Response to Submissions

Hera Mine Modification 3 PA 10_0191

R.W. CORKERY & CO. PTY. LIMITED

September 2015

Figure 1	Registered Groundwater Bores – Non-Project Related.....	5
Figure 2	Amended Final Landform and End Land Use.....	11

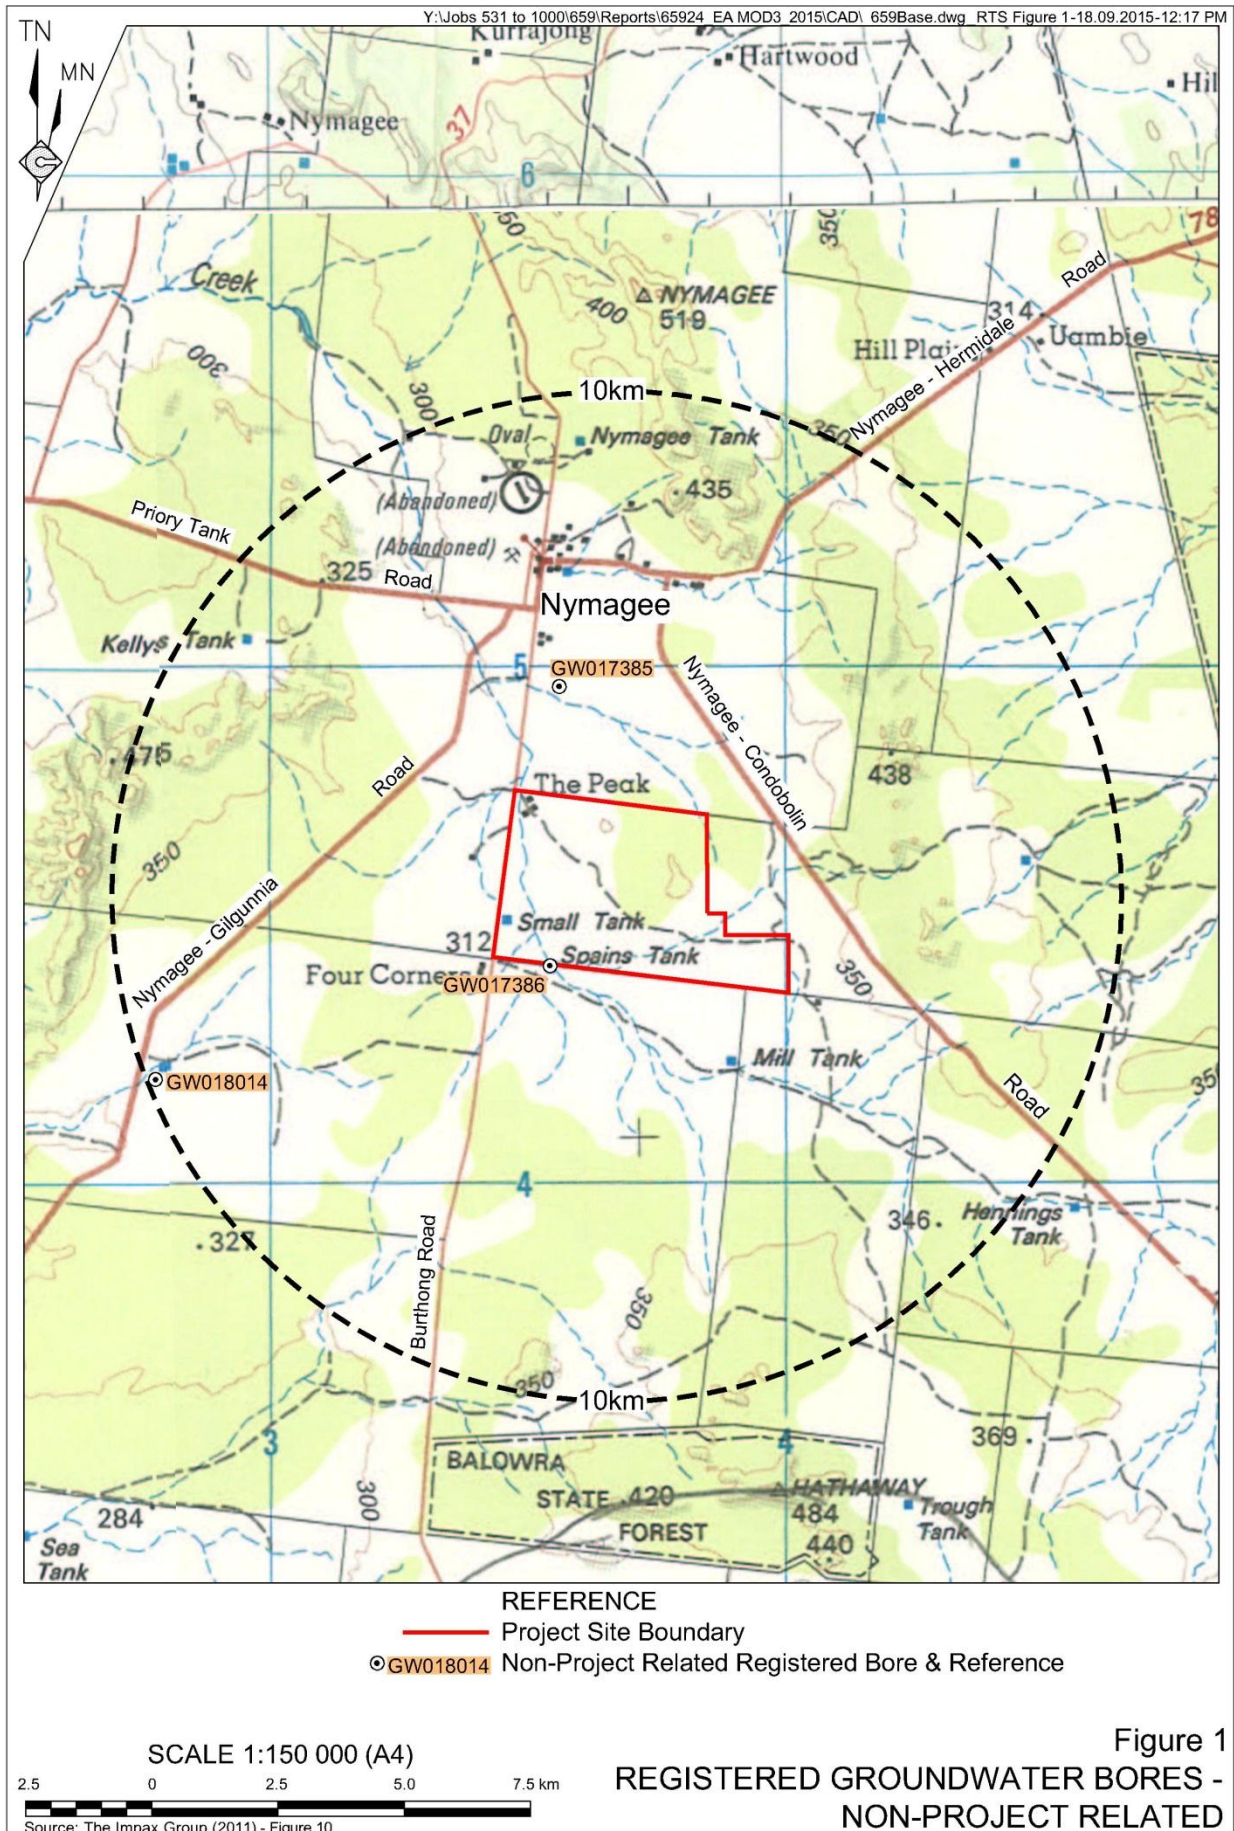
The ability to meet the additional water demands has been assessed in Appendix 3 of the EA. This assessment has not adequately assessed the potential impacts on neighbouring bores or considered the development of monitoring and management to mitigate impacts in accordance with the NSW Aquifer Interference Policy.

Revise or develop a new groundwater assessment report that focusses on potential impacts to basic landholder rights water users, licensed water users and the environment due to the proposed water demands.

Include the additional proposed bore extraction locations in any revised groundwater assessment to more accurately represent impacts and provide opportunities to minimise potential off-site impacts where possible.

Three, non-Project related registered bore exist within 10km of the Project Site. **Figure 1** presents the location of each bore and **Table 1** summarises the publicly available information for each. In summary, the closest non-project related bore to the Project Site is GW173386. That bore is located immediately to the south of the Project Site and was identified during the original application for Project Approval as potentially impacted. The Proponent notes that the bore is equipped with a windmill but that the windmill is not connected to the bore. The Proponent is not aware of the bore being used since 2005 when Mr Stuart Jefferies, a senior employee of the Proponent, became involved in the Project.

The original application for Project Approval identified that standing water levels in bore GW017386 would be likely to be impacted by the Project as it was then understood. Aquade (2015) also determined that the bore would be likely to be impacted should further extraction of groundwater be undertaken. However, neither the original application nor Aquade (2015) indicated that the extent of groundwater drawdown would affect standing water levels in bores GW017385 or GW018014. As a result, the Proposed Modification would not result in impacts on additional surrounding groundwater users.

In light of the above and the fact that the Proposed Modification would not result in additional bores being impacted and that measures are already in place to address anticipated impacts, the Proponent contends that a revised groundwater assessment is not required. In addition, the Proponent notes that it is not able to provide detailed locations of proposed bores at this stage because the exploratory drilling has yet to be undertaken.

Y:\Jobs 531 to 1000\659\Reports\65924_EA MOD3_2015\CAD\659Base.dwg_RTS 2 Amended Final Landform-18.09.2015-12:15 PM

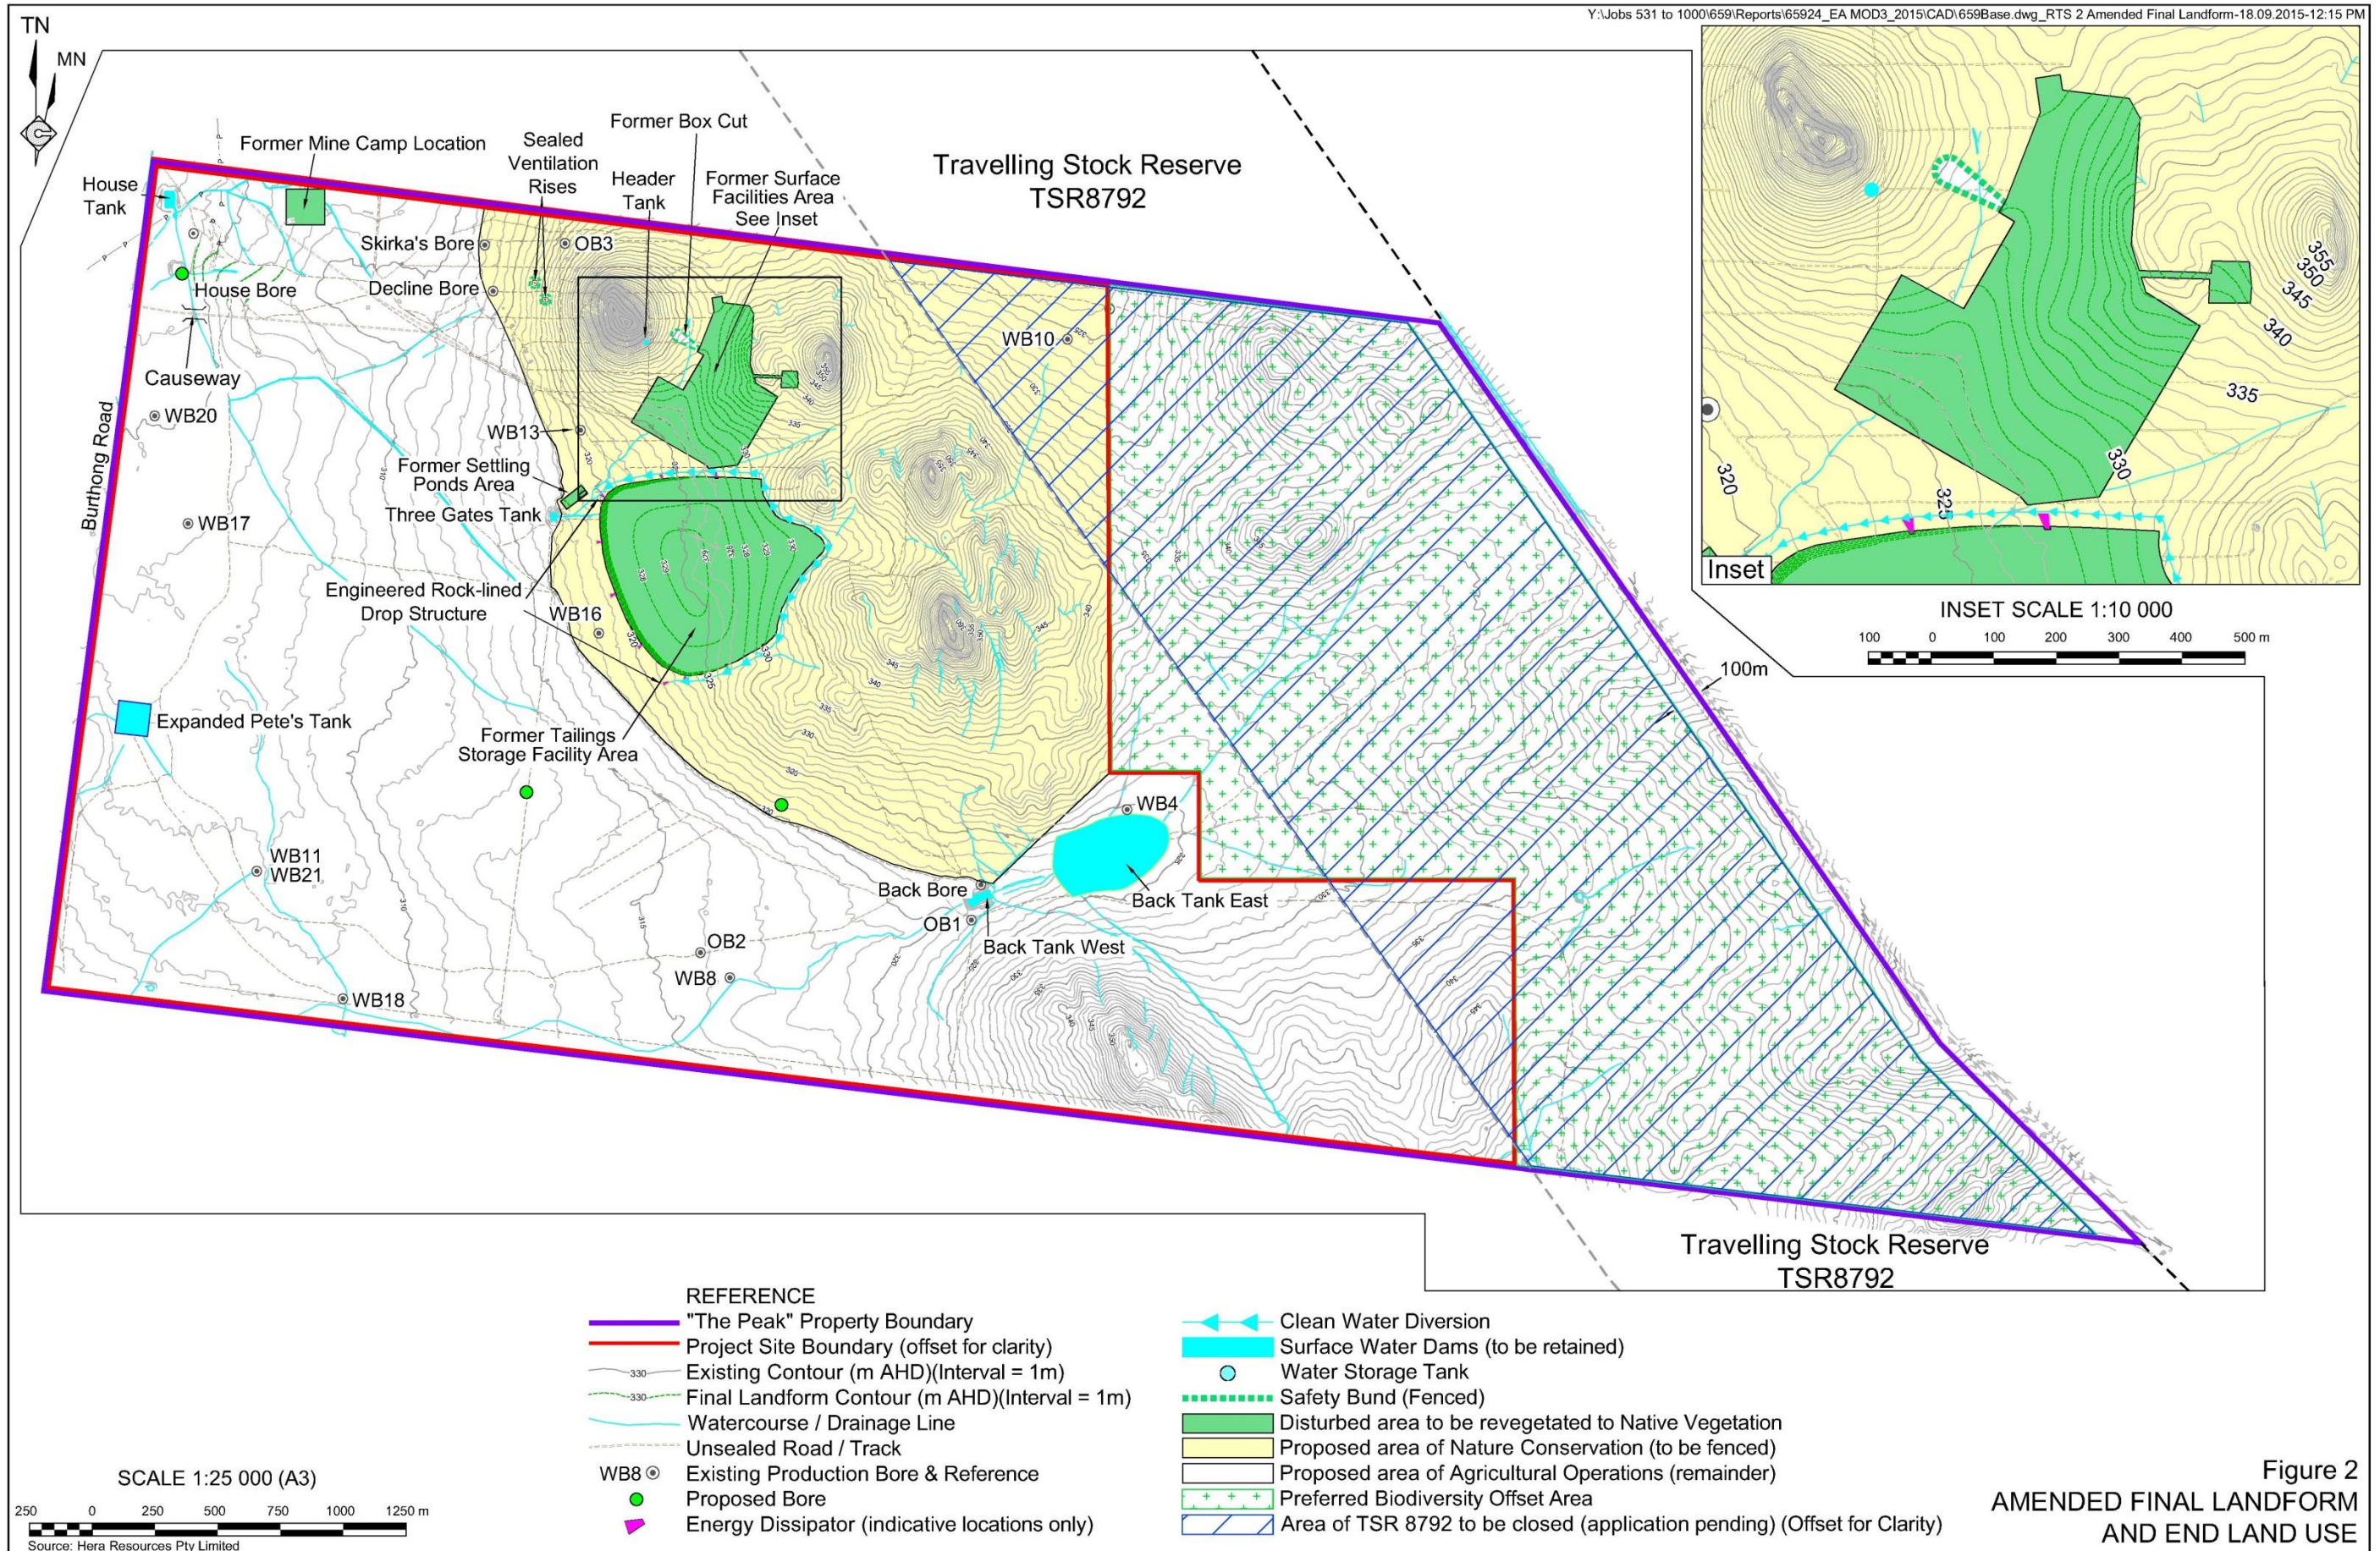
The EA does not provide detail of the revised final landform figure and that there is no a definitive commitment to the remove of material stockpiled at the proposed Northern WRE.

The Division requires a figure that depicts the proposed final landform and land use(s) for the project area, and surrounding undisturbed environment. Include contours, vegetation types, drainage infrastructure and any other retained built infrastructure; and confirmation that there is no change to the current commitment to completely remove all stockpiled waste rock prior to closure as described in the 2011 EA.

Figure 2 presents the proposed final landform for the Project Site, taking into account the Proposed Modification. In summary, the Proponent would ensure that the following is implemented during rehabilitation of the Mine Site.

- All potentially acid forming waste rock within the Southern Waste Rock Emplacement would be transported back underground and placed with areas to be inundated with groundwater.
- All non-acid forming waste rock remaining within the proposed Northern Waste Rock Emplacement and the ROM pad would be used for rehabilitation purposes, including (in priority order):
 - capping of the Tailings Storage Facility;
 - establishment of surface water controls on the final landform; and
 - backfilling or partially backfilling of the box cut.
- The proposed disturbed areas would be rehabilitated as described in Section 2.9.5 of RWC (2015) and the MOP.
